**KNOXVILLE/KNOX COUNTY METROPOLITAN PLANNING COMMISSION
 SUBDIVISION REPORT - CONCEPT**

▶ **FILE #:** 6-SJ-07-C **AGENDA ITEM #:** 12

▶ **SUBDIVISION:** WILDWOOD GARDENS

6-SJ-07-C
CONCEPT PLAN

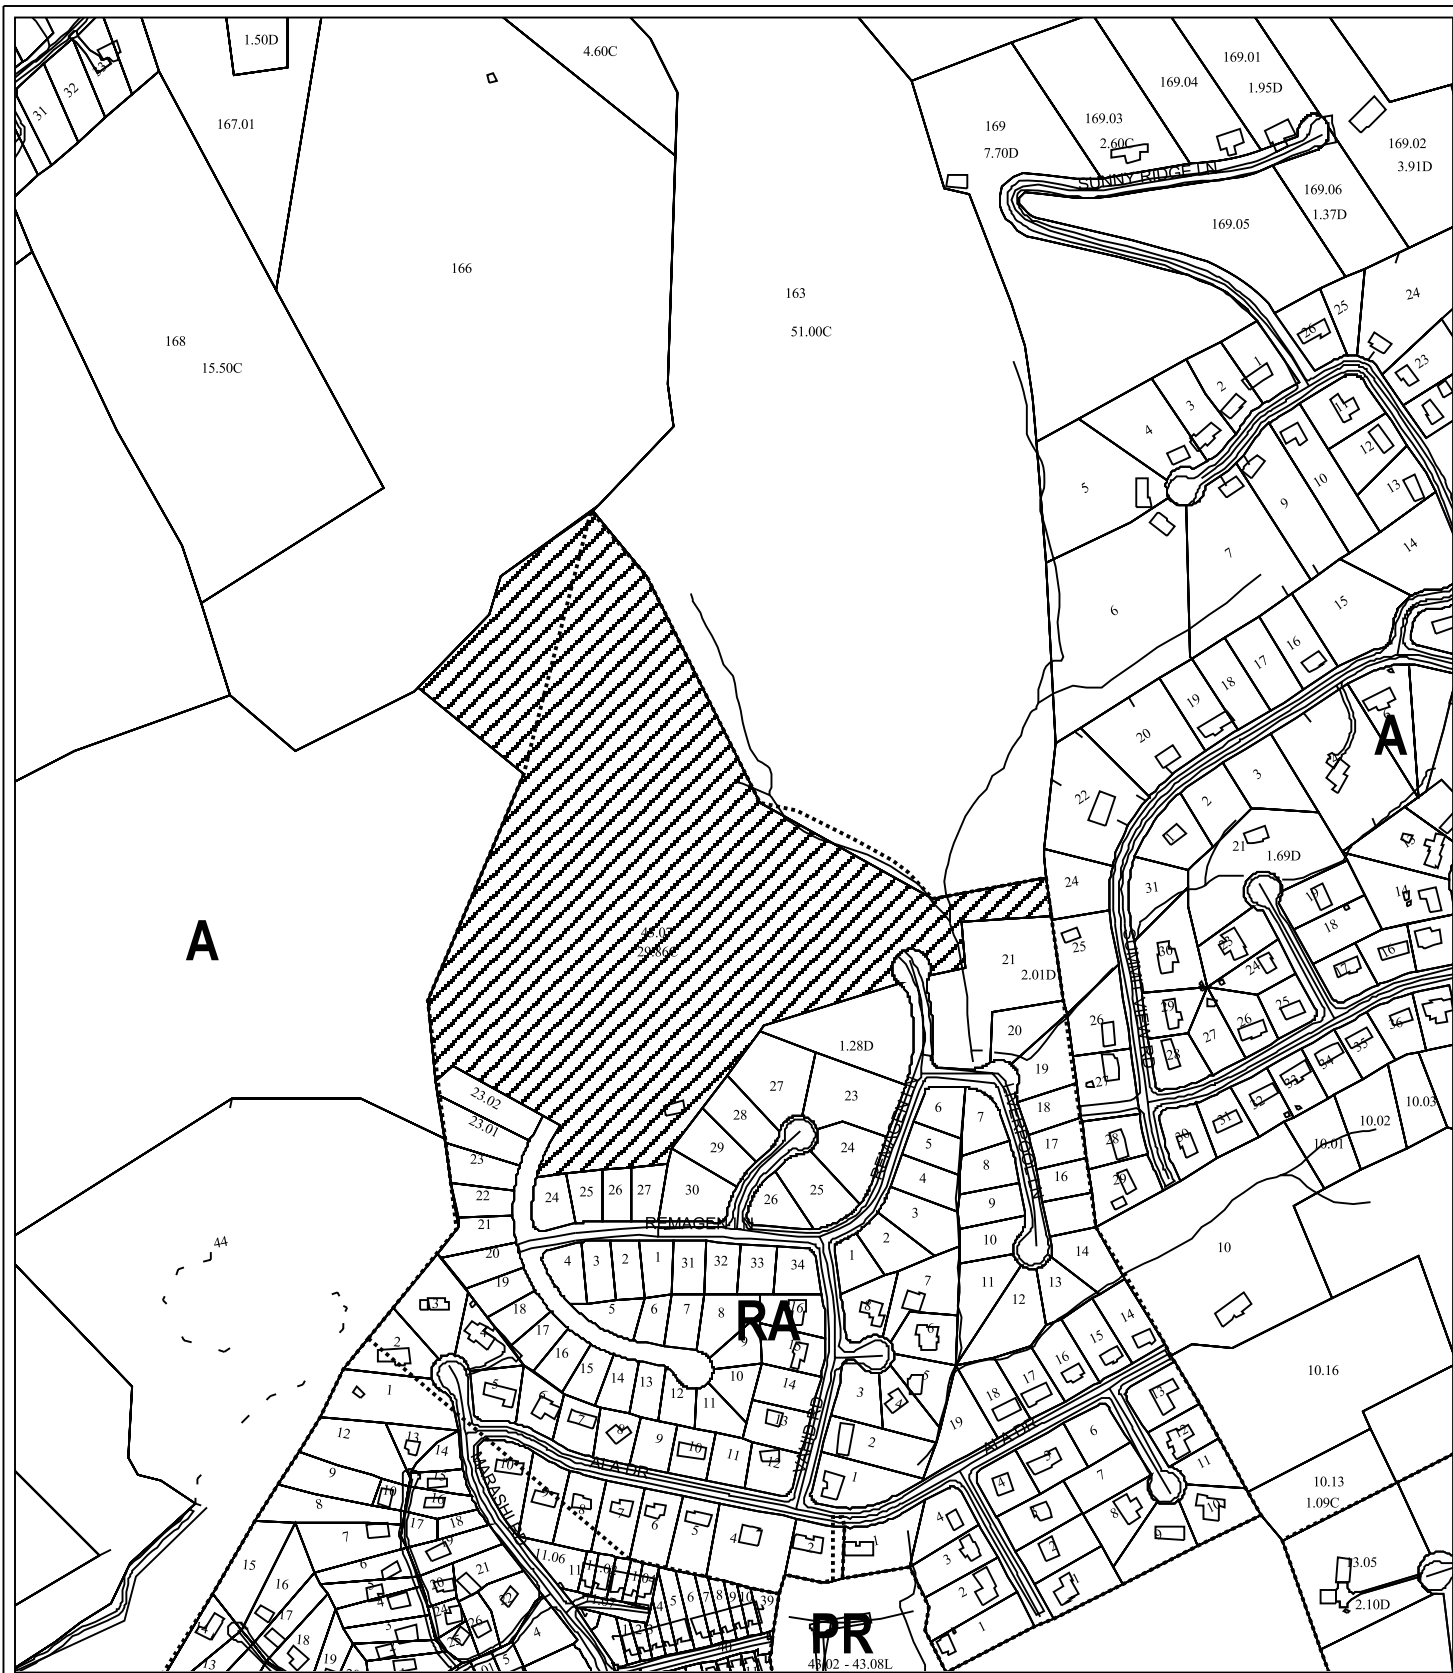
The plan as submitted shows 45 lots with the average lot being 75' wide and containing 11,000 square feet. Based on the plans and topographic data submitted to MPC staff for review, practically all of the lots are being developed in areas where the natural topography exceeded 25% grade. A large portion of the lots will be in areas where the topography exceeded 40% grades with the grades of some lots exceeding 50%. Based on the natural topographic constraints of this site, the development of this site should have been done under the hillside development standards as called for in Section 82-33 of the Knoxville Knox County Minimum Subdivision Regulations. Under those provisions of the Subdivision Regulations, the lots would have to be a minimum of 100' wide and have a lot area of 25,000 square feet.

However, since the grading that has been done on this portion of the site has significantly altered the natural grade, staff has required the applicant to submit plans that will reflect the proposed topographic conditions of the site upon completion of the grading. Staff has received the proposed grading plan and it proposes that no lot will have grades that will exceed a three to one slope.

Finally, there are two hatched contour areas on the site that have already been altered. Development around the areas will be controlled by the Knox County sinkhole policy. A number of the proposed lots have been eliminated and the fifty foot buffer from the edge of the depressions has been shown on the latest plan. Any construction within the 50' buffer may only be undertaken after the completion of a geotechnical study of the lot has been reviewed and approved by the Knox County Dept. of Engineering and Public Works. The Knox

County Sinkhole Policy requires that a 5' easement be established 5' outside the highest hatched contour. Staff will require special construction techniques in the vicinity of these depressions and buyer notification.

APPROVE the Concept Plan subject to 11 conditions

8. If any building construction is proposed within the 50' buffer areas around the sinkholes designated on the Concept Plan, a geotechnical report must be prepared by a registered engineer to determine soil stability and that report must be submitted to the Knox County Department of Engineering and Public Works for consideration. Any construction in this area is subject to approval by the County following review of the report. Engineered footings may be required for this area. The sinkholes and 50' buffer shall be designated on the final plat even if they are approved to be filled.

10. Grading each lot so as the slope of the lot does not exceed a 2 to 1 slope ratio. Lots that are steeper than a 3 to 1 slope ratio must provide a 15' wide usable rear yard between the rear of the dwelling and the slope
